21555 Non-Transparent PCI-to-PCI Bridge

Specification Update

December 2002

Order Number: [278337-008](#)

Figure 1. Node Boundary

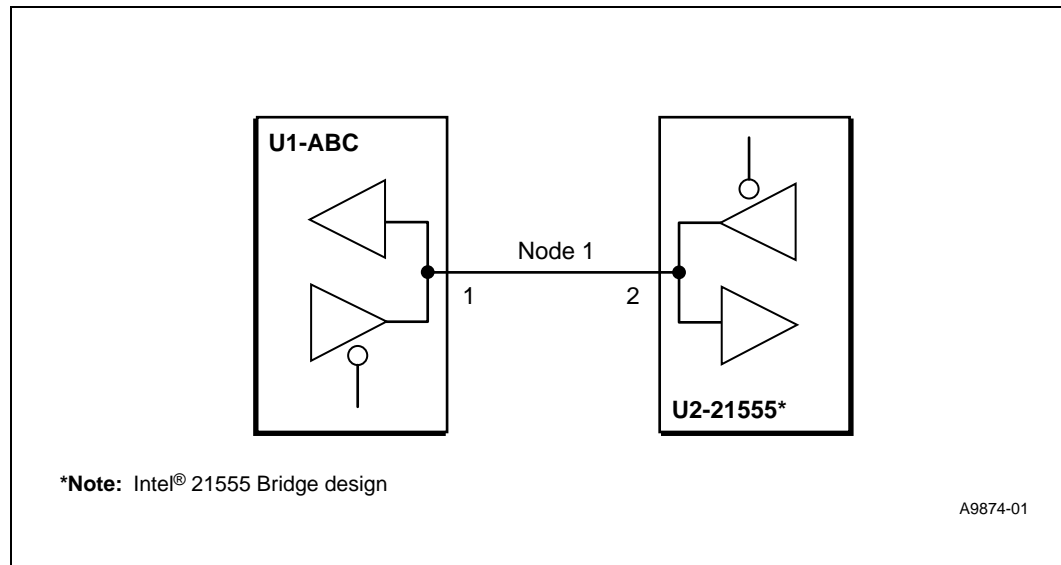
1. 21555AA/BA boundary Scan Implementation is not compliant with IEEE 1149.1

Problem: There is a one cycle delay before valid BSDL data is pushed out to the pins. The problem is due to an incorrect inversion in the equation that generates the JTAG update.

Implication: The parallel output data from any bi-directional pins, purely output pins or control cells, will be driven out exactly one clock after the UPDATE state. This is in violation of the IEEE1149.1 Specification.

To understand the potential issue in detail, refer to the diagram below. Node 1 is a bi-directional node, with U1.1 and U2.2 connected as shown. Assuming that U1 is an IEEE1149.1 compliant device, that U2 is the 21555, and that the control cells of the 21555 were set during the vectors to enable the driver of U2.2 to drive to U1.1 (receiver). When switching drivers from U2 to U1, U2 should tri-state its driver prior to, or at the same time as, U1 enables its driver. Since the 21555 UPDATES its Parallel Outputs one clock late and the control cells which enable U2's drivers are Parallel Outputs which again updates one clock cycle late then U2.2, which will be driving at the same time U1.1 is driving. This contention will happen for one TCK cycle, until U2 UPDATES its parallel outputs. The period of this contention is dependent on the TCK frequency rate.

Workaround 1: In-Circuit testers should test for the parallel output data to be on the pins of the chip, at least one clock after the UPDATE state. Typically Automated Test Pattern Generator (ATPG) test vectors will test for this state upon exiting the UPDATE state. This test should be delayed one clock from the ATPG vectors. Also, In-Circuit testers should ensure that data is driven onto pins of the 21555, one clock after UPDATE, to avoid any potential of back driving a pin.

Workaround 2: Standalone boundary scan testers and In-Circuit testers performing chained boundary scan tests, should understand that the Parallel Output UPDATE data, being delayed by one clock, may cause bus contention and back driving during that one clock period, assuming the vectors change bus driving sources in one vector. This is because in chained boundary scan tests, all components execute TAP instructions in Parallel (or lock step), and vector generation algorithms optimize the number of vectors.

A remedy to the 21555's late UPDATE is to ensure the chained Boundary Scan tester's vectors do not switch bus driver directions in one vector. This means that one vector should disable U2's driver, and the next vector should enable U1's driver. ATPG vectors typically are not manually manageable in this way and this requirement may force an engineer's manual intervention. No single stepping of test clock through the TAP State Machine should be allowed with the 21555 in the boundary scan chain. The resulting contention would increase the potential back drive time, increasing the possibility of device damage.

Status: Fixed. This behavior has been corrected in the 21555AB/BB Step A3 device.

Figure 12-1. Signal trst_I States

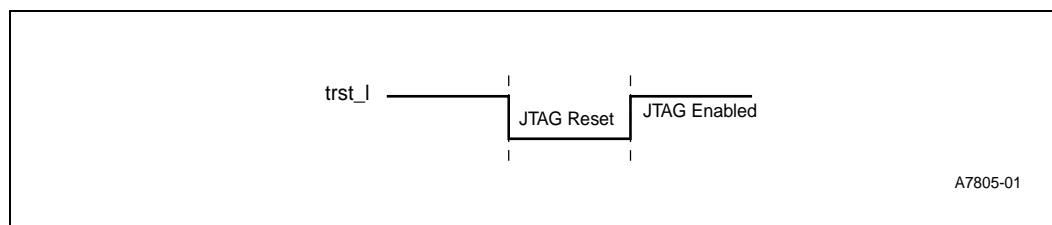
13. Change to Initialization Section 12.2.1 and JTAG Description

Issue: Change to second paragraph. Also made a change to normal operation description note for JTAG below Figure 12-1. The section now appears as follows:

The test access port controller and the instruction register output latches are initialized and JTAG is disabled while the **trst_I** input is asserted low (see Figure 12-1). While signal **trst_I** is low, the test access port controller enters the test-logic reset state. This results in the instruction register being reset which holds the bypass register instruction. During test-logic reset state, all JTAG test logic is disabled, and the device performs normal functions. The test access port controller leaves this state only after **trst_I** (low) goes high and an appropriate JTAG test operation sequence is sent on the **tms** and **tck** pins.

Note: Prior to normal 21555 operation, this signal must be strobed low or pulled low with a 1k Ω resistor.
